UNITED STATES PATENT AND TRADEMARK OFFICE

10/591,510

Eugen Kloos

Office Action Summary	Application No. 10/591,510	Applicant(s) KLOOS ET AL.	
	Examiner Melody M. Burch	Art Unit 3657

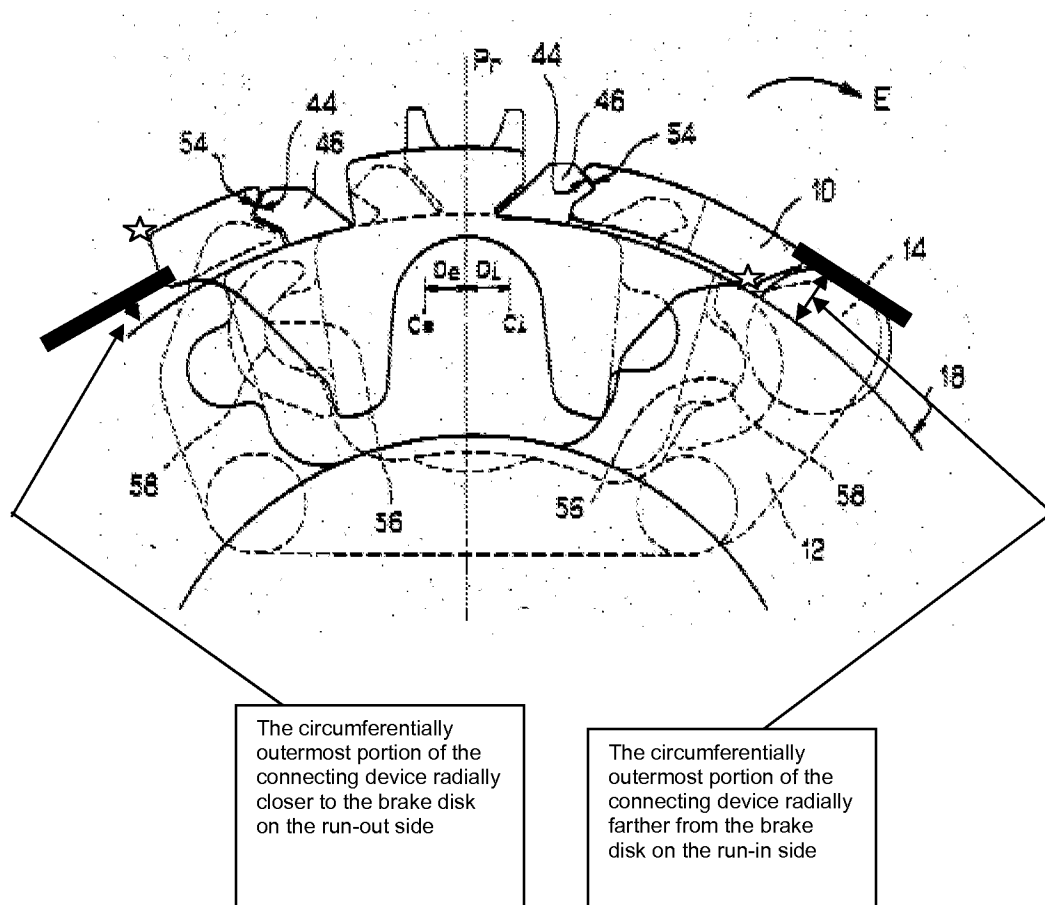
Alternatively, one could interpret the claim such that the circumferentially inner portion in the area of the right star in the annotated figure on pg. 6 is the connecting device radially closer to the brake disk on the run-out side and the circumferentially inner portion of the connecting device in the area of the left star in the annotated figure on pg. 6 is the connecting device radially farther from the brake disk on the run-in side.

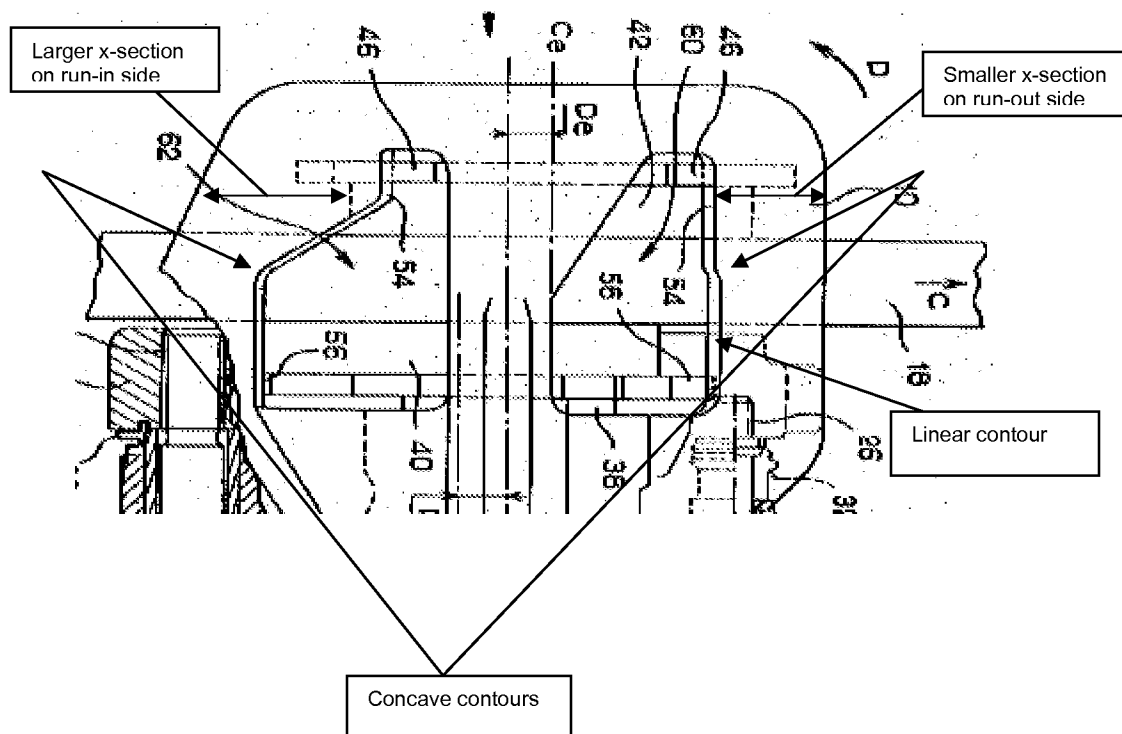
Re: claims 10-12. Mery et al. show in the annotated figure below the limitation wherein in the projection parallel to the brake disk, the opening has a concave contour on the brake disk run-in side and a more or less linear contour on the brake disk run-out side and that this more or less linear contour forms and acute or obtuse angle with the plane of the brake disk.
